D350-822-011
Job Sheet 184111

Part Name: PA100 PUREair System for AS350/EC130

DART SERVICE INSTRUCTION

TO AMEND INSTALLATION INSTRUCTIONS IIN-D350-822 REV. H AND INSTRUCTIONS FOR
CONTINUED AIRWORTHINESS ICA-D350-822 REV. 6 OR LATER APPROVED REVISION

Figure 1 - QB21308 Assembly Screen

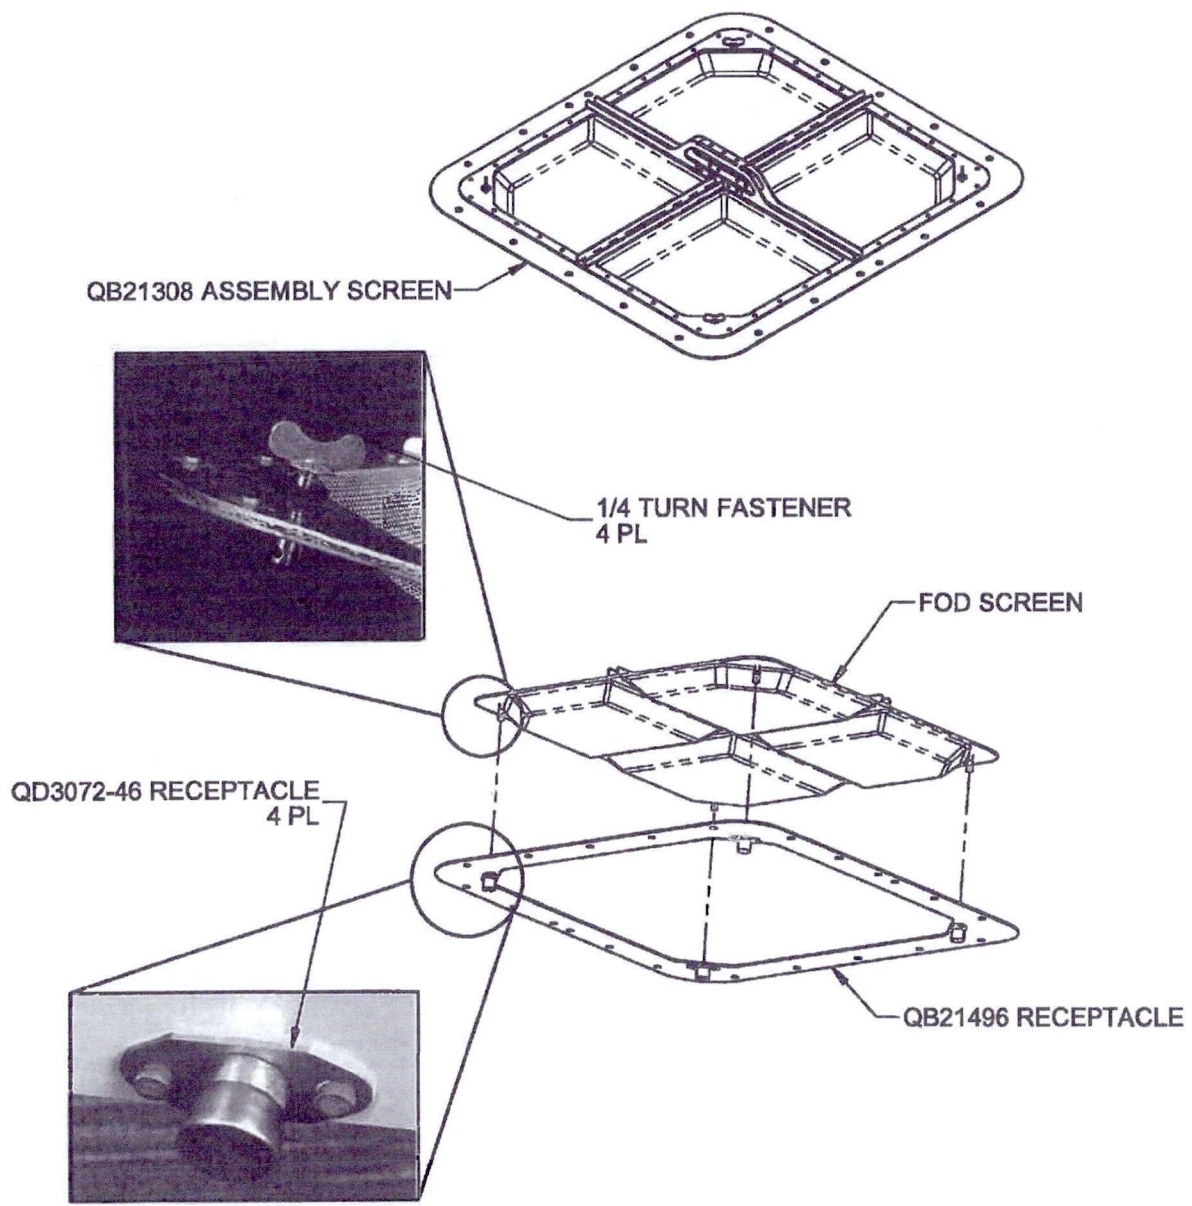
The purpose of this Service Instruction is to facilitate the replacement of the QD3072-46 Receptacles that are installed on the QB21308 Assembly Screen manufactured by Pall Aerospace as part of the D350-822-011/-013 PA100 PUREair System with the DSI 9815-011 Replacement Receptacle kit. The intent of this DSI has been incorporated into D350-822-011 at CHG 005 and D350-822-013 at CHG 003.

- 2.1.3 Separate the FOD screen from the QB21496 Receptacle by turning the 1/4 turn fasteners and lift the FOD screen per Figure 1.
 - 2.1.4 Drill out the retaining rivets and remove qty(4) QD3072-46 Receptacles from the QB21496 Receptacle. Remove any adhesive residue.

- NOTE: Although not generally necessary, it is acceptable to use longer or shorter MS20426AD3-X Rivets
- 2.1.8 Remove qty(4) 1/4 Turn Fasteners from the FOD Screen per Figure 1.

Figure 2 - DSI 9815-011 Replacement Receptacle Kit

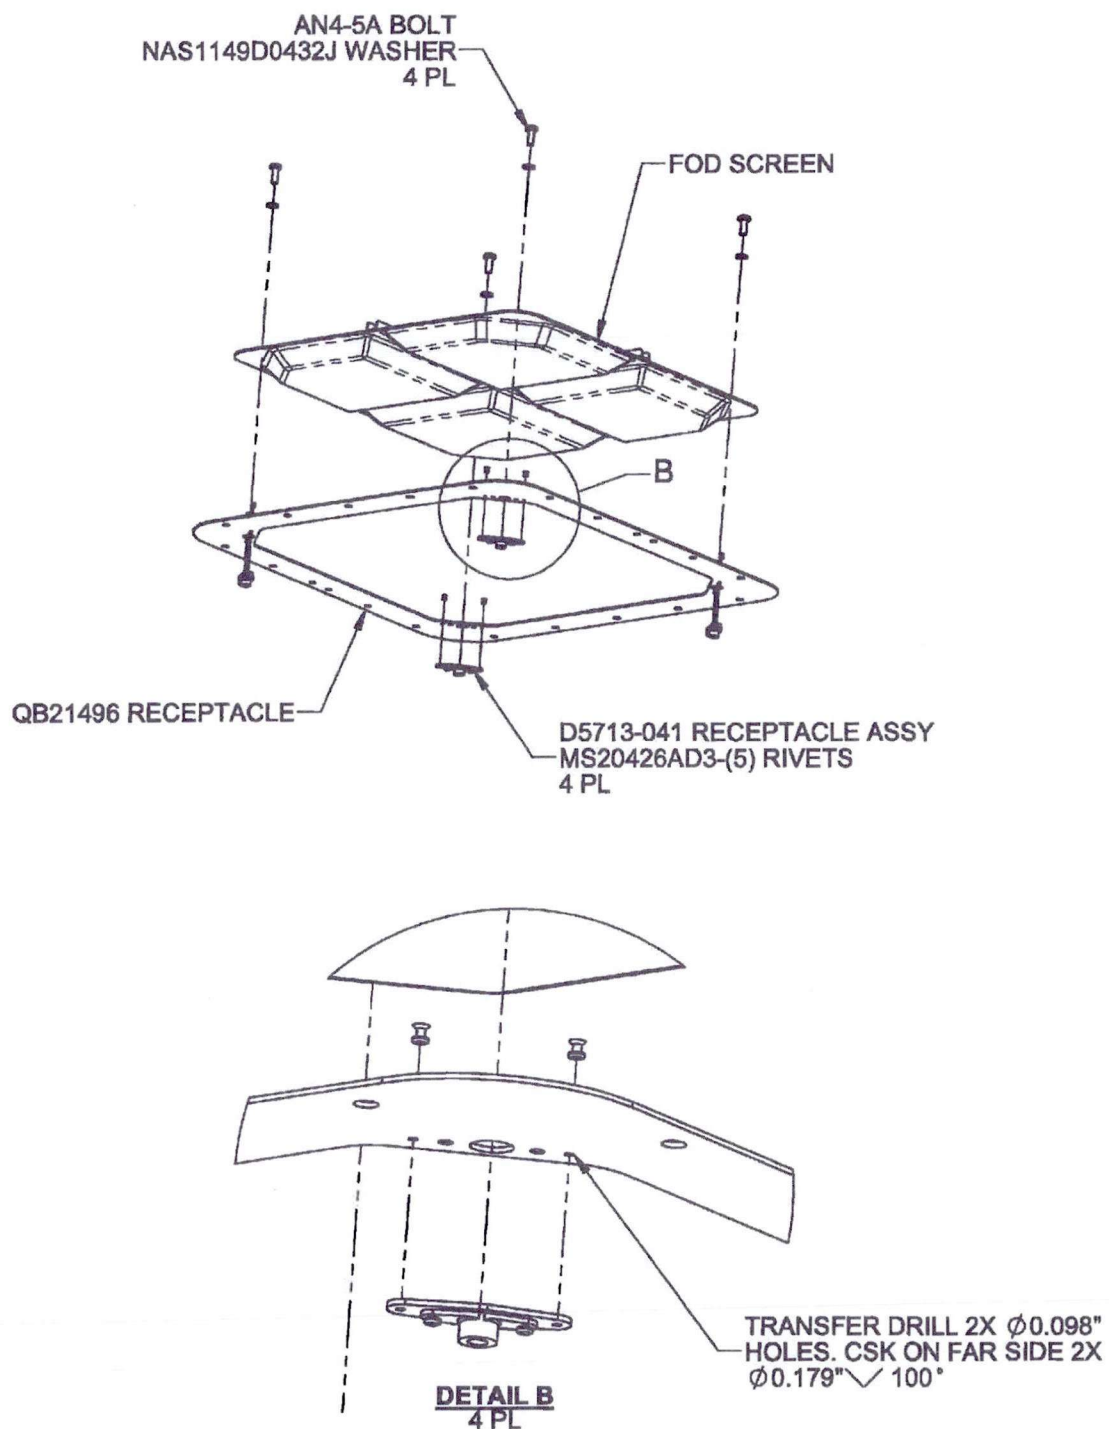
- 2.1.5 Position the qty(4) D5713-041 Receptacle Assy in the location shown in Figure 2. Transfer drill 2x $\phi 0.098$ " holes with CSK $\phi 0.179$ " $\angle 100^\circ$ on the top side from the D5713-041 Receptacle Assy to the QB21496 Receptacle. Touch up holes with Alodine 1200 per MIL-C-5541.

- 2.1.6 Mask nutplate holes and touch up the affected areas with prime and paint per ICA-D350-822.
 - 2.1.7 Install qty(4) D5713-041 Receptacle Assy with qty(2) MS20426AD3-(5) Rivets per Figure 2.

- 2.1.9 Reinstall the FOD screen on the QB21496 Receptacle using qty(4) AN4-5A bolts and qty(4) NAS1149D0432J Washers per Figure 2. Torque bolts to 50-70 in-lb (5.6-7.9 N-m).
